**20-COA-0192**  
**1334 S. 2<sup>nd</sup> St.**

**Old Louisville Architectural Review Committee**  
**Public Hearing**

**Bradley Fister, Historic Preservation Specialist**  
**February 17, 2021**

### Part 3

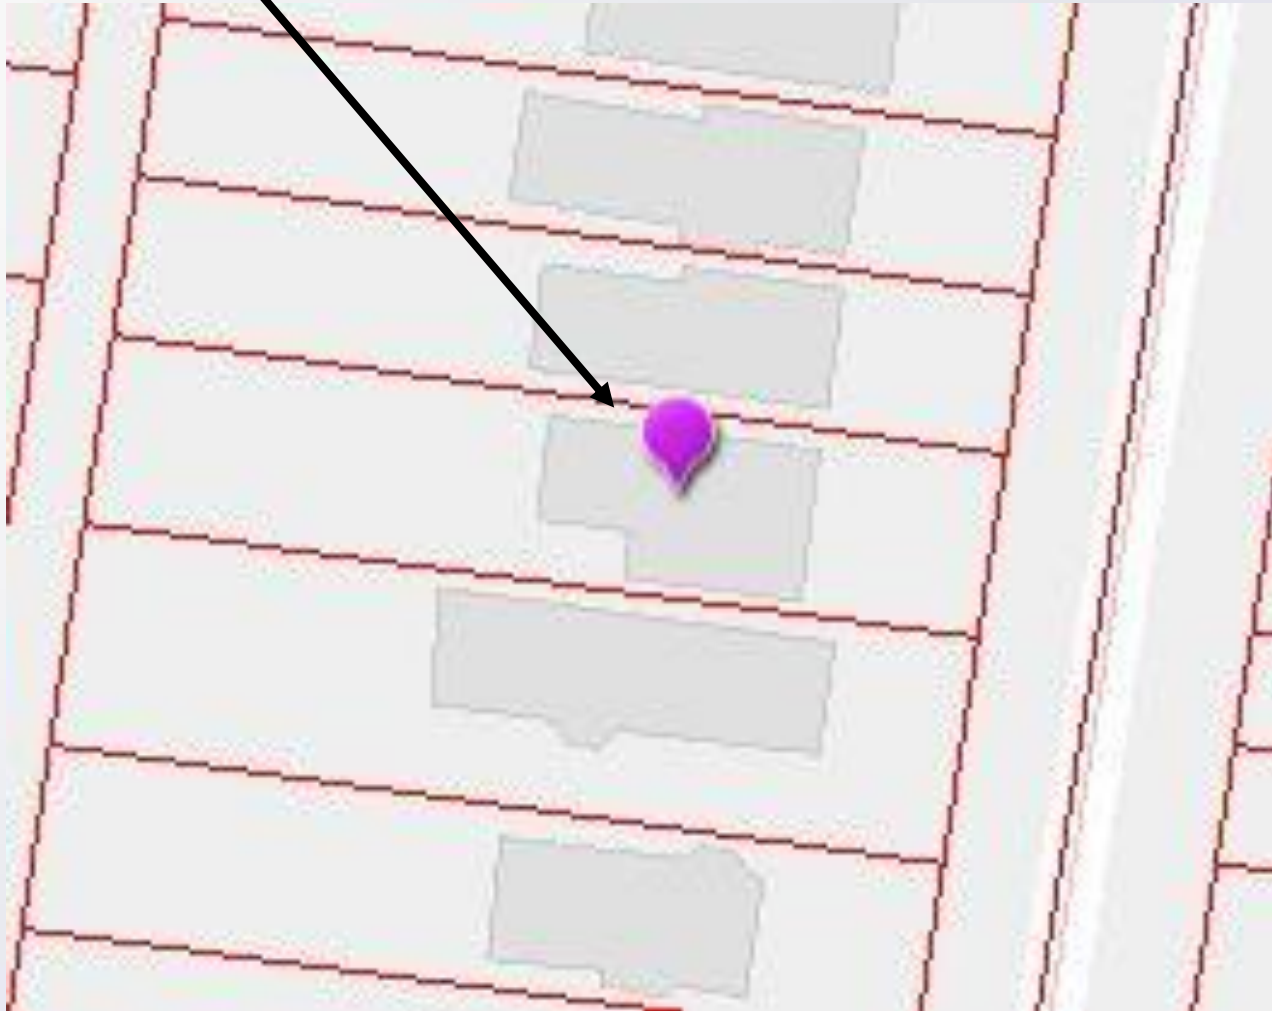
The applicant also seeks approval for an after-the-fact brick terrace placed in the front of the home on either side of the stairs leading to the stoop. The terrace extends outward from the stairs to the north approximately 9' toward the property line; the terrace extends outward from the stairs to the south approximately 15' toward the opposite property line. The terrace extends outward from the foundation of the building on both sides approximately 6' toward the direction of S. 2<sup>nd</sup> St., and abuts the existing brick walk on either side.

- The terrace is flush with the ground and not visible from the street. The fencing that is along the terrace and between the risers is below 2.5' and serves more as a landscaping border feature than an actual fence. The proposed brick risers generally do not meet the Old Louisville Design Guidelines for **Site**.

On the basis of the information furnished by the applicant, Staff recommends the application for a Certificate of Appropriateness be **approved** with the following conditions.

- 1. The terrace in the front yard shall not be extended further without staff approval.**
- 2. No additional fencing shall be installed beyond the terrace.**
- 3. If the design or material changes, the applicant shall contact staff for review and approval.**
